**ADDENDUM NO. 2:**  
The following changes and additions shall be made to the plans and proposal. When this addendum conflicts with the specifications, plans, or special provisions, or Addendum # 1, THIS ADDENDUM SHALL GOVERN.

CITY OF WICHITA  
**TRAFFIC SIGNAL PLAN  
KELLOGG & MAIZE ROAD**  
SEDGWICK COUNTY

**Professional Engineering Consultants, P.A.**  
303 S. TOPEKA • WICHITA, KANSAS 67202  
316-262-2691 • FAX 316-262-3003

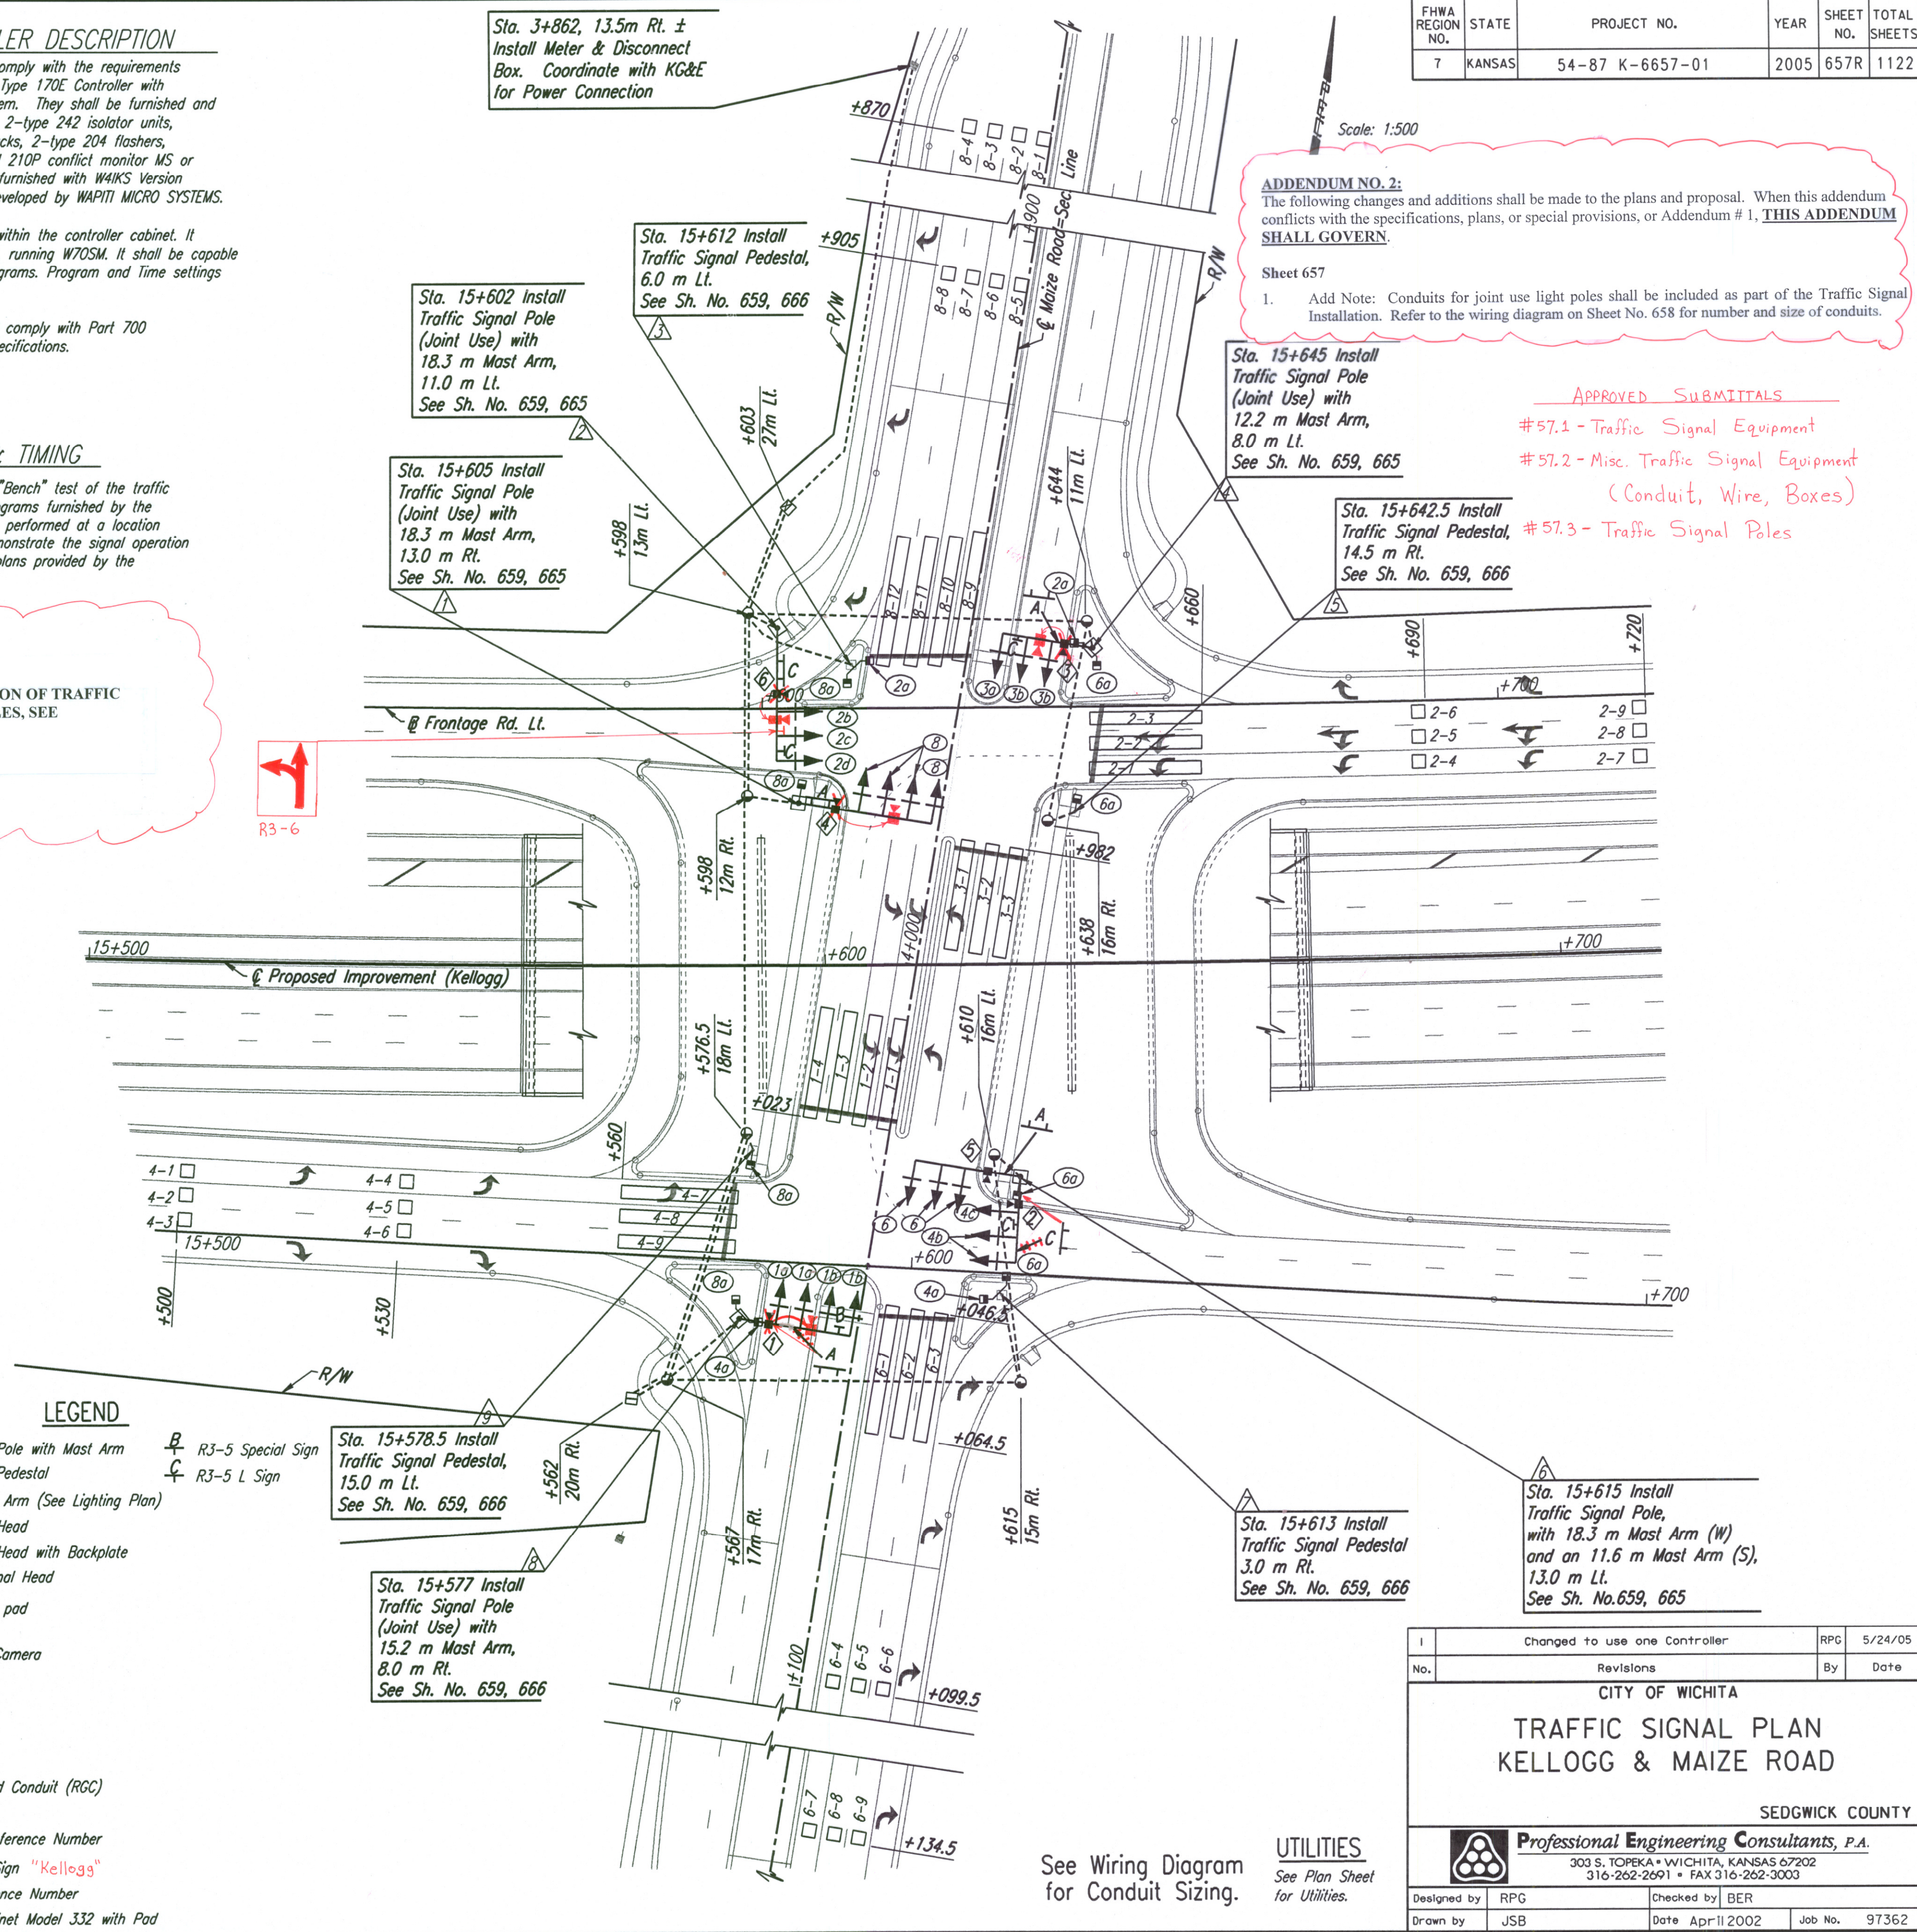
Sheet 657  
1. Add Note: Conduits for joint use light poles shall be included as part of the Traffic Signal Installation. Refer to the wiring diagram on Sheet No. 658 for number and size of conduits.
